Product Change Notification

Date Issued :	November 22, 2022	PCN Number :	513039	
Reason for Change :	Retraction			
Description of Change :	This notification is to inform you of the correction of PCN# 513024 for the "Series Title" in the first slide. For details, please see the part highlighted in yellow. The rest of the content is the same as notified before.			
		24: This notification is to inforn ist. This change may result in a	n you about changes that are being made t change to the raw material.)	
Reason for Short Notice :	Special Request			
Assessment of Change :	Reliability Test Report/s			
Planned Implementation Date :	January 01, 2023			
Sample Availability Date:	November 21, 2022			
Internal Molex Qualification Date :	November 21, 2022			
Last date to request Samples by Custo	mer: December 18, 2022			
Traceability Code Markings / Date :	Lot information on label			
Before Picture

Change Overview

55487 series SD Correction of errors. This is a PCN to correct the errors that were found in our SD for MicroTPA Single Row Dip Vertical type Header Assembly.

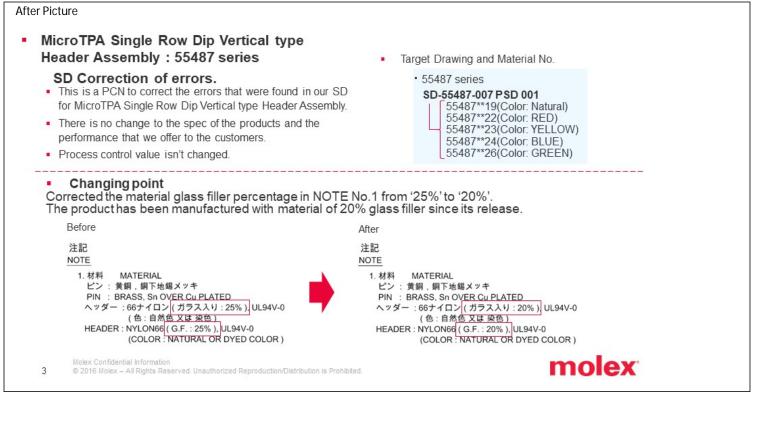
• Due to Toray's Flame Retardant shortage, there is a shortage of PA66 glass fiber containing resin, and it is difficult to supply the target connector, so we will switch to Asahi Kasei.

Series Number	Series Title	Current	New Resin
55487****	MICROTPA 2.0 W/B SINGLE ROW VT DIP HEADER	TORAY PA66	ASAHI PA66 20% GF NA UL94V-0
55755****	MICRO TPA 2.0 HEADER ASSY VT	20% GF NA UL94V-0
